ADDENDUM NO. 2

DATE OF ISSUANCE: March 21, 2023

PROJECT: 2023 Henryville Flooring Replacement
Phase 2 & Cafeteria Expansion
213 N. Ferguson. St.
Henryville, IN 47126

ARCHITECT'S PROJECT NO.: 21-47.007

SHEET NUMBER
A502
202147.007

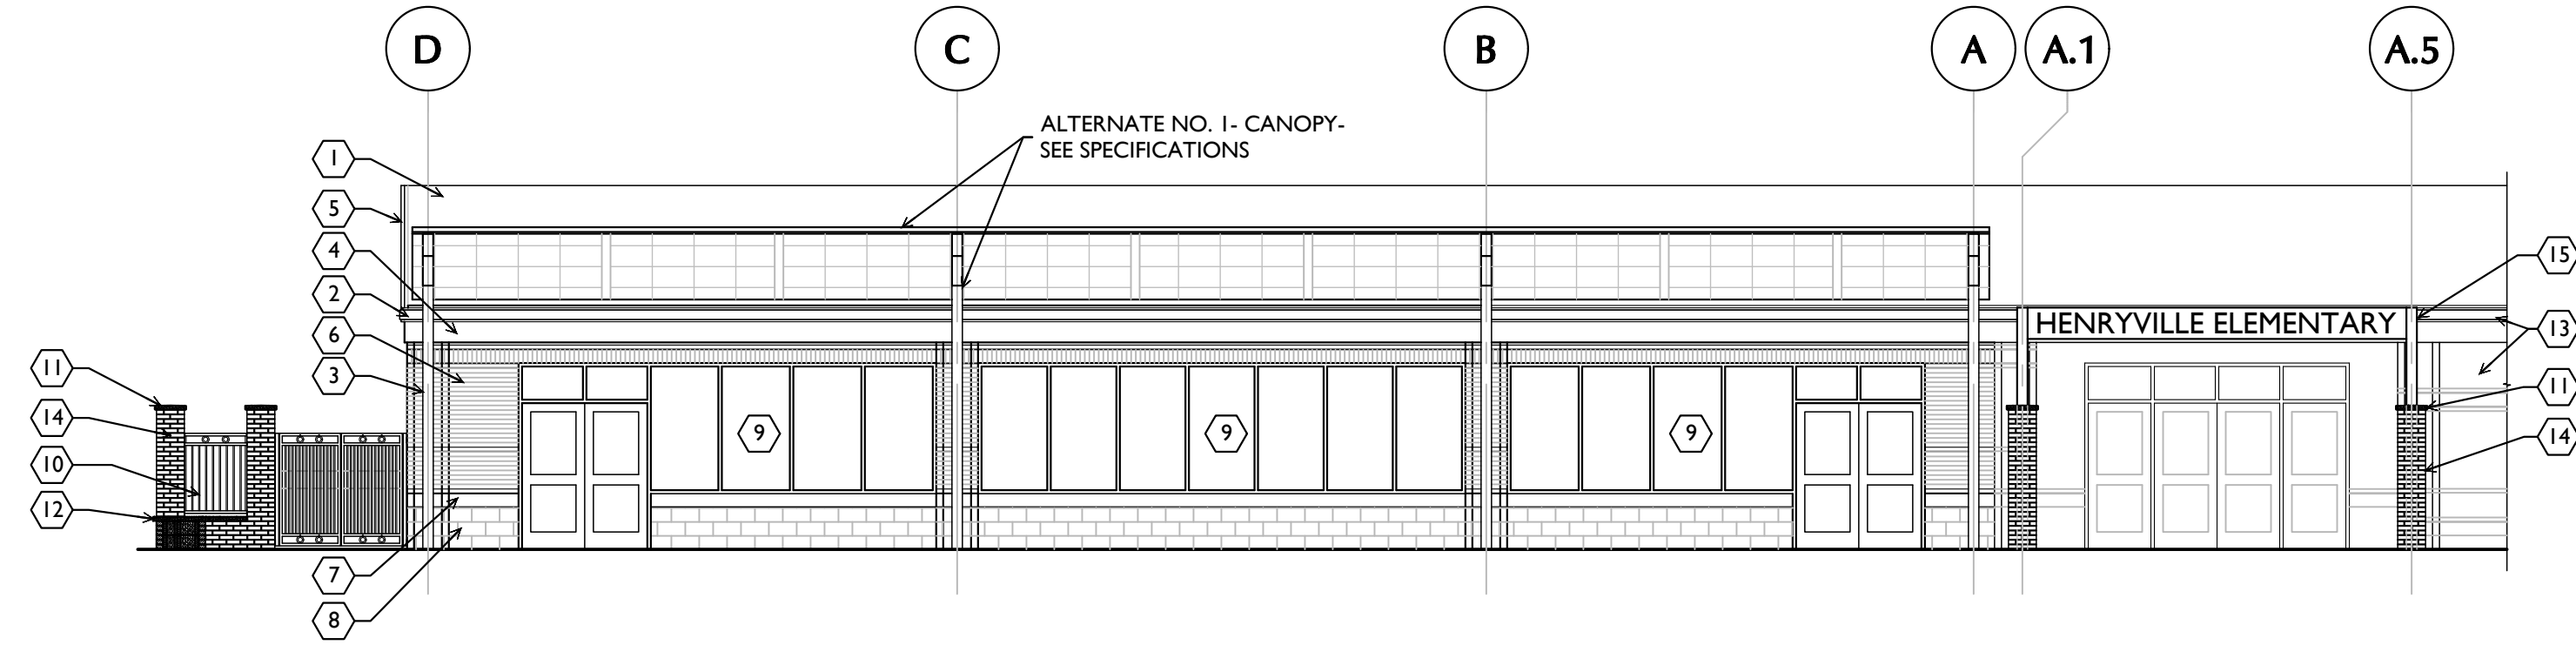
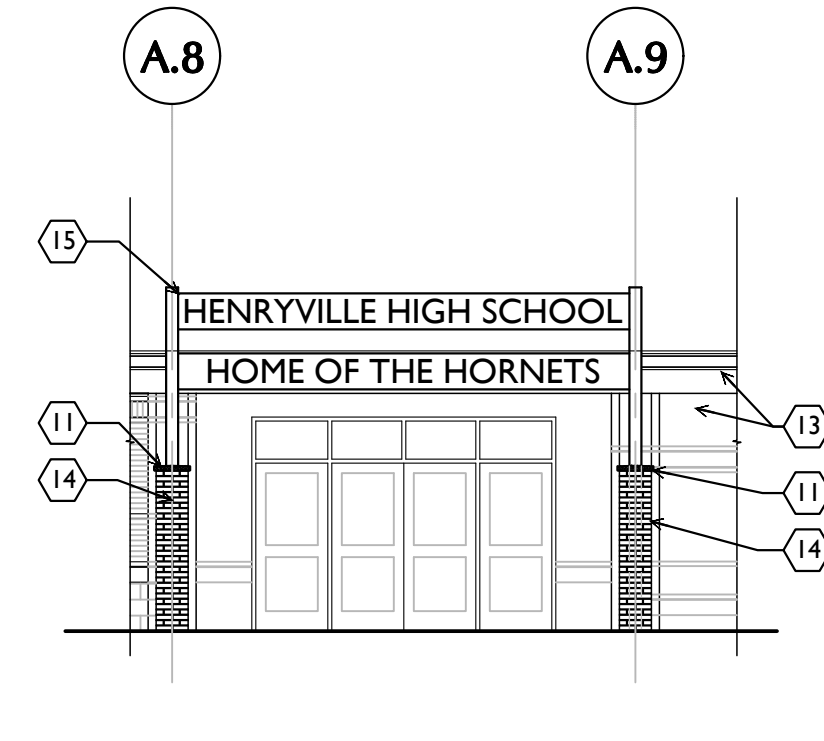
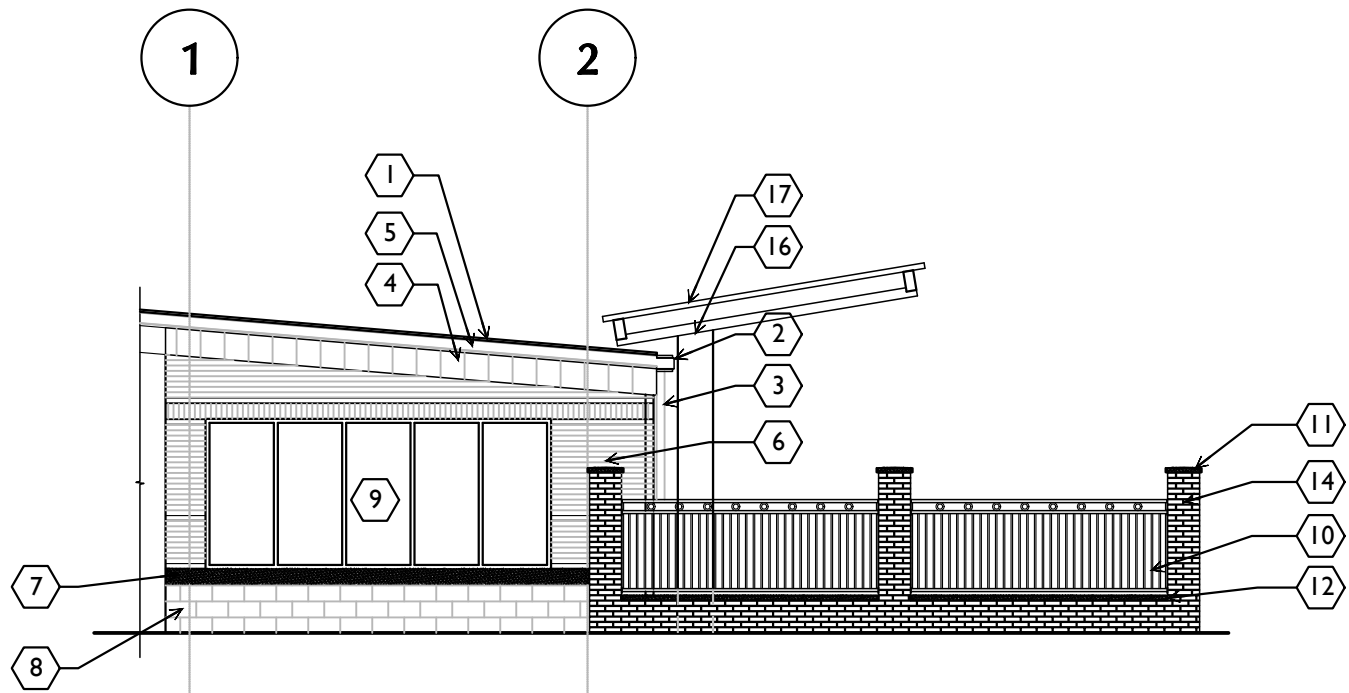
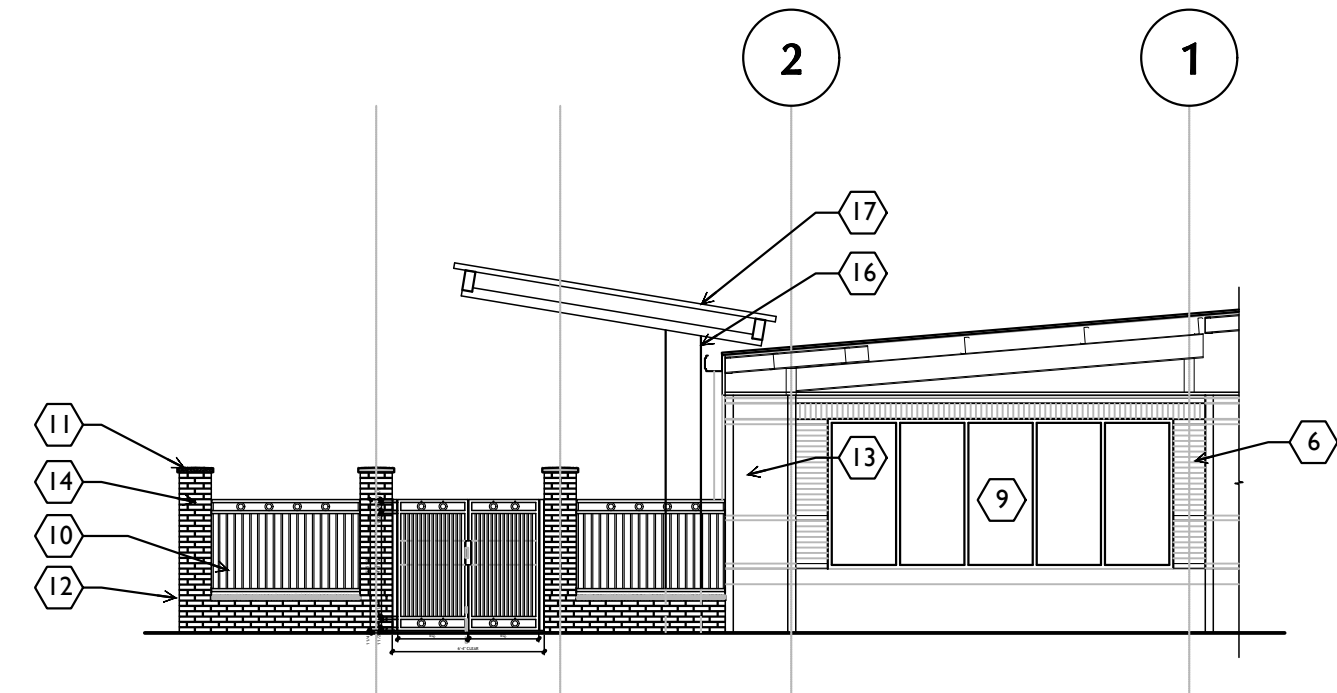
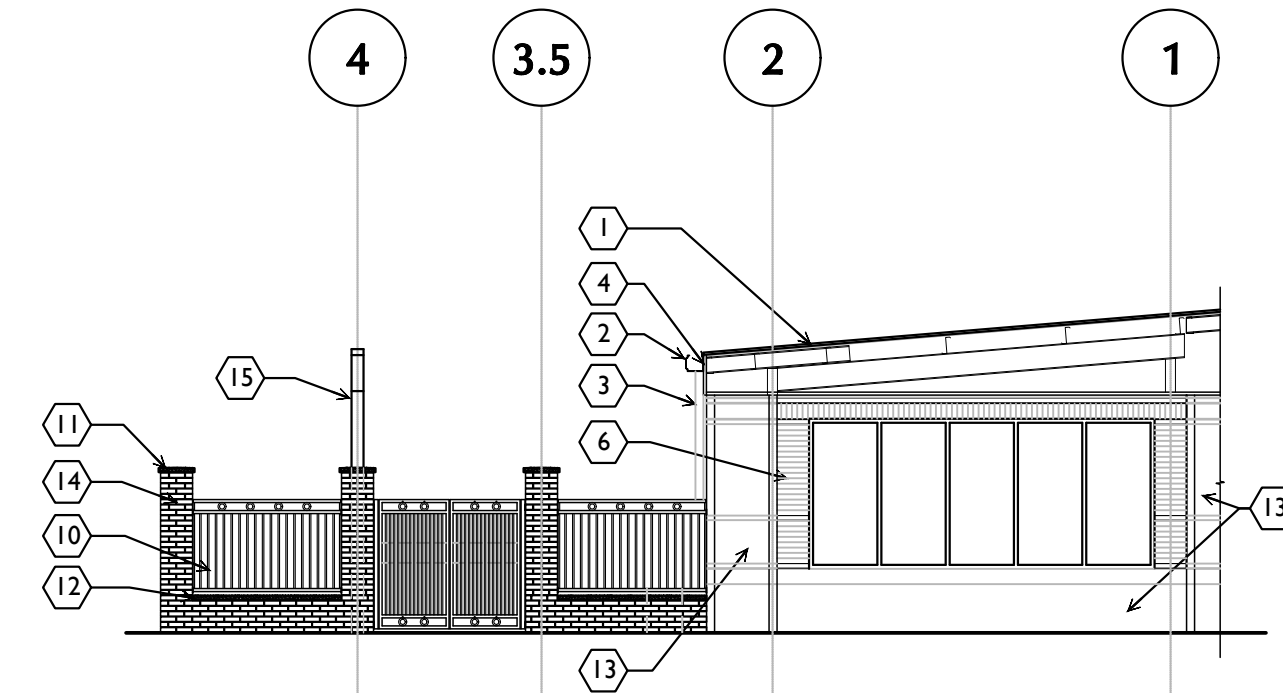
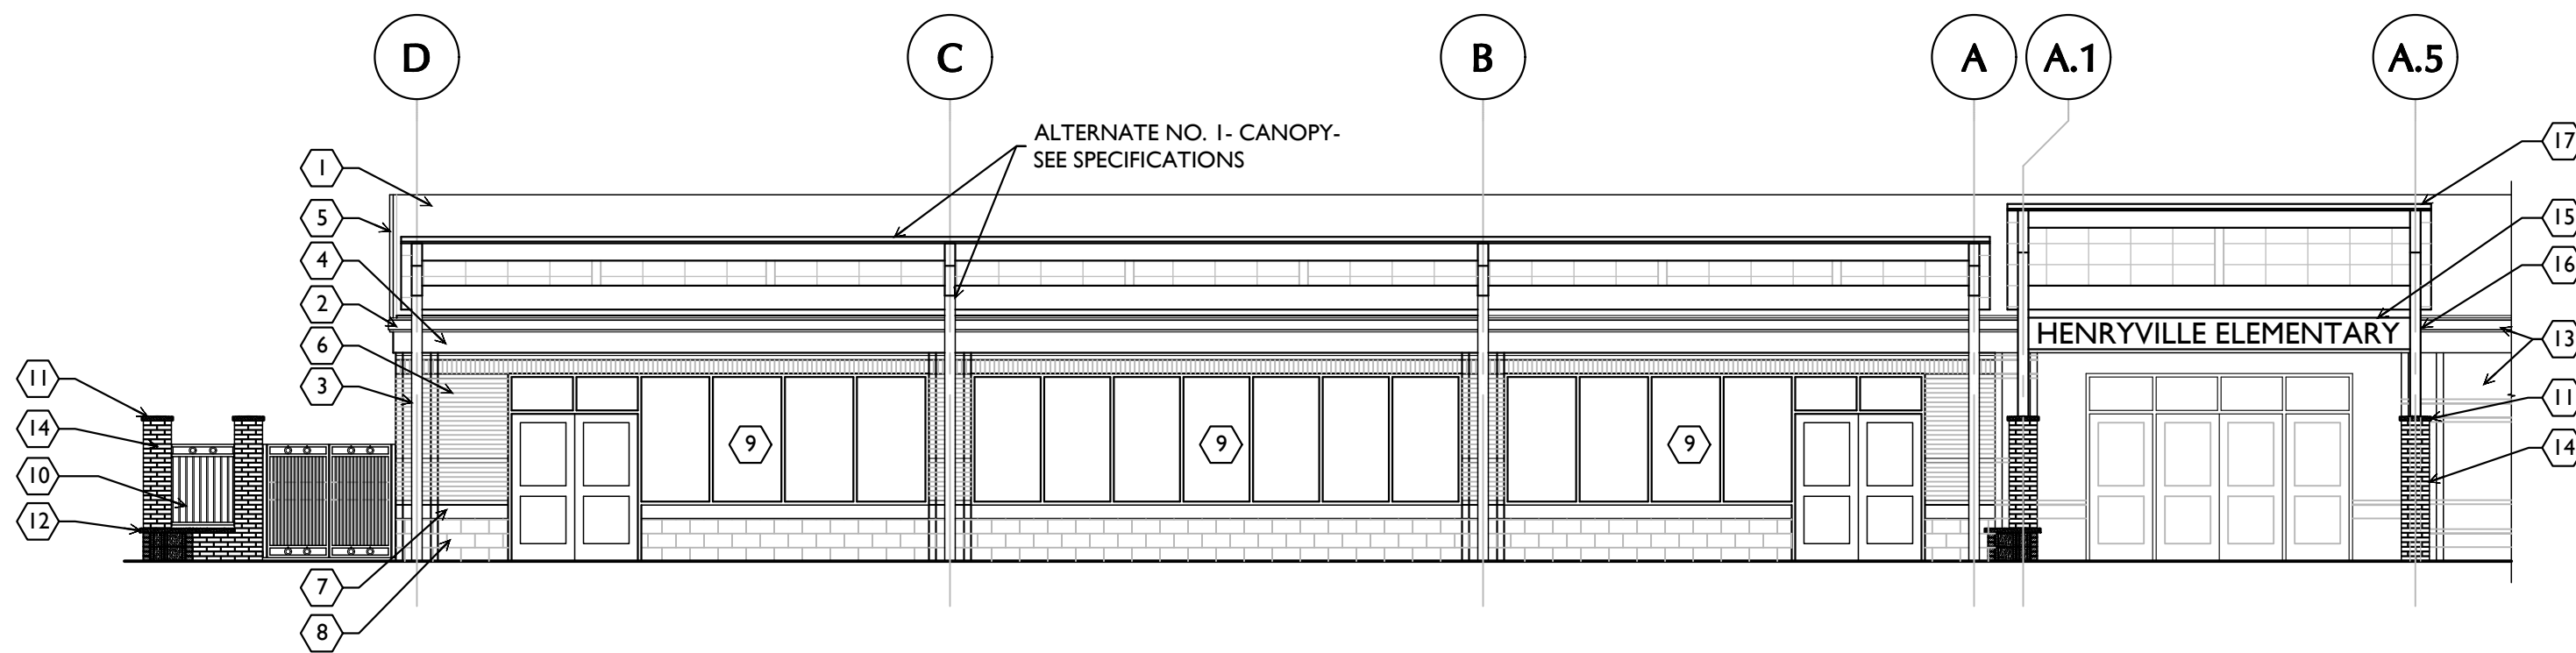
ADD-1 Item No. D-9 - Exterior Elevations

Refer to Sheet(s): A502

Add attached Drawing in its entirety; drawing includes elevations for Alternates No. 1, 2A, and 2B.
